SOFTWARE SERVICE BULLETIN

NO.: 0409

SUBJECT: GTX 330/330D GTX 33/33D* Software Upgrade to Version 3.06

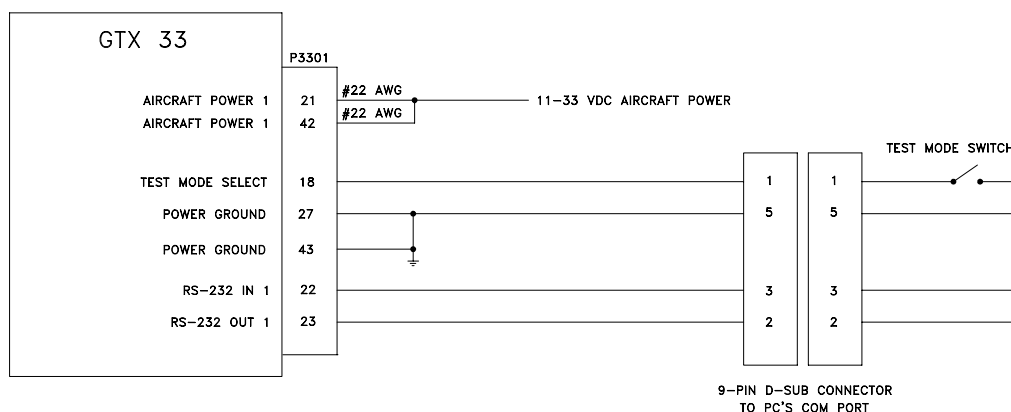
1. Use a test harness for the GTX 330/GTX 33 as shown in the following figure:

2. Ensure that the unit is turned off. Connect the GTX 330/GTX 33 to the test harness and apply power to the harness.
3. With the unit off, enable test mode via the Test Mode Switch. (Applies a ground to P3301 pin 18).
